CABINET MEMBER FOR HIGHWAY MANAGEMENT – 1 JULY 2021 SHIPTON UNDER WYCHWOOD – MILTON ROAD - PROPOSED WAITING RESTRICTIONS

Report by Corporate Director, Environment and Place

Annexes Annex 1: Consultation Plan

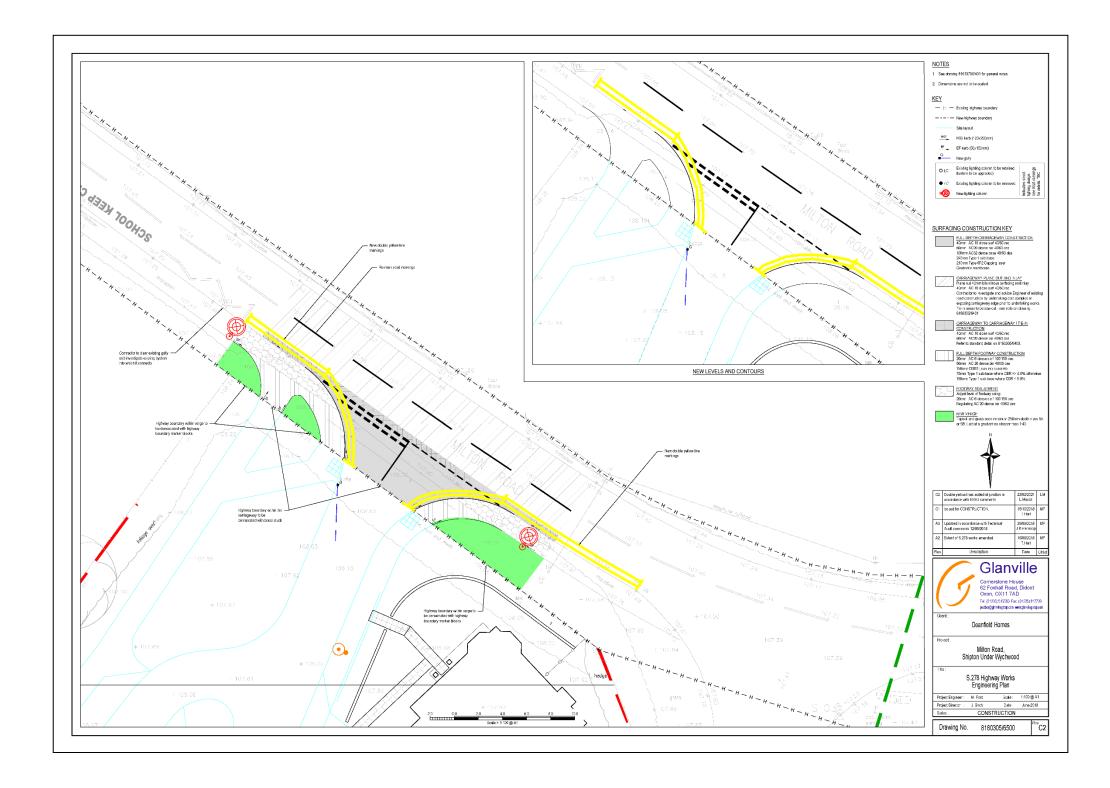
RESPONDENT	COMMENTS
(1) Traffic Management Officer, (Thames Valley Police)	No comment
(2) Local Resident, (Shipton-under- Wychwood)	Object – I would like to object to this proposal as the parking restrictions will force parents to park in the development and increase traffic. I have 2 cats who I am extremely worried about endangering.

(3) Local Resident, (Shipton-under- Wychwood)	Object – We strongly object to this proposal for the following reasons: There is dedicated parking specifically for school drop offs and pick-ups at the start and end of the school day on the development in Oak Drive on the adjacent road running alongside the playground (though having only just been completed, from what we can see, the system is not up and running at present, no school gate yet). At this stage, it is too soon to know how this new system will work out and, in our view, too hasty a decision to be planning double yellow lines adjacent to school in Milton Road. There are security gates at either end of the road leading into the dedicated parking road adjacent to access road on Oak Drive and, if locked for part of the day, parents/visitors would need an alternative space for the occasional drop-off during the day outside school at Milton Road. If this space is not available, it is likely the private access road in Oak Drive will be used when gates are locked. Residents have been advised by the Property Management service responsible for overseeing this development that vehicles should not park along the access roads to the development. This has already started to happen at drop off and pick up times. This is wholly unacceptable and not what was agreed when we purchased the property. We cannot be put in the invidious position of "policing" parking outside our houses during pick up and drop off times and possibly at other times during the school day when the potential for this to happen will be greater if no parking spaces are available within close proximity to the school. When the system of pick up and drop off is properly underway this should considerably ease traffic congestion on Milton Road and could obviate the need for double yellow lines on Milton Road.

(4) Local Resident, (Shipton-under- Wychwood)	Concerns – I am generally supportive of the proposed restriction. However, I have some concerns and would ask you to consider some changes.
	Concern #1: Parking during school arrival and collection is already a very considerable problem. At these times there are already cars parked on the south side of Milton Road all the way from this corner down to the service station. Recently this has got much worse with cars also sometimes parked on the north side pavement and verge between Castle Bank and the gate into the sewage farm and solar farm.
	This additional restriction may cause parking on the pavement outside the houses on the north side (including Castle Bank), often with people claiming "it is only for a moment", with significant reduction in width, as well as obstruction and dangers to pedestrians and to children crossing the road.
	Concern #2: The new development (Oak Drive) included space to provide additional parking for the school. That is not yet in use as the developers are still using it, but it is not clear how effective that will be as it is very small, has a very limited number of spaces, and is likely to often be used by the Oak Drive residents as overflow parking if they have more than one car or are using their garages for other purposes.

Suggestion #1: Also add a single yellow line along the north side of Milton Road from the Oak Drive corner all the way to the bridge across the stream at the garage. This is not currently generally used (except as described above) and vehicles should never be parking on this side during school hours - the restriction would be to avoid people starting to use it. A single yellow line would probably be fine as the occasional car or business vehicle parking on that side at evenings or weekends would not be a problem.
	Suggestion #2: Add parking restrictions in the school car park in Oak Drive to make parking restricted to use for school drop-offs and pickups on school days (say, 8AM to 5PM).

(7) Local Resident, (Shipton-under- Wychwood)	Support – I think it might be an idea to make the double yellow lines continue further into Oak Drive than proposed, because people may try and park along the street and thereby block the road. We live opposite the new development. Getting in and out of our drive is difficult at the best of times. At school dropoff and pick-up times, this is made much worse by cars parked close by. Also, we live on a blind bend and cars coming around this bend won't see parked cars close to or at the entrance of Oak Drive.

(8) Local Resident, (Shipton-under- Wychwood)	No objection – We live on Oak Drive, right beside the junction and have been watching out our kitchen window at parents parking on the zigzag lines by the school, the double yellow lines beside the zigzag and on the double yellows at the other side of the junction. Unfortunately, the drop off zone is not open at one end yet, so not in use, although this morning a couple of sensible parents were using it by going in at the exit and turning around so parking safely before walking around with their children. Plenty other parents are coming into Oak Drive to drop off, then doing three point turns in residents' driveways and this morning one car reversed into the drop off zone as a large lorry was coming out - not ideal. One stupid driver drove into the junction with Milton Road, then reversed by out onto the road narrowly avoiding a car coming from Milton. We welcome any measures you can do to help parents park sensibly before an accident takes place. Could the head teacher be made aware of the problems and perhaps a traffic warden for a couple of mornings and afternoons would get the message across? They would only be needed for 45 mins each time.

- 11. Noting the above comments, the proposed restrictions are considered essential on highway safety grounds to ensure that adequate visibility is available at the new junction.

- 12. On the suggestions received for additional measures, the school parking area when available for use will not be highway and its management would be primarily a matter for the Wychwood C.E. Primary School The suggested possible provision of single yellow lines is outside the scope of this specific scheme but could be considered subject to funding and consultation after monitoring the demand for on-street parking once the school parking area is operational, noting that the member of the public making the suggestion indicates that parking in any case does not routinely occur here.
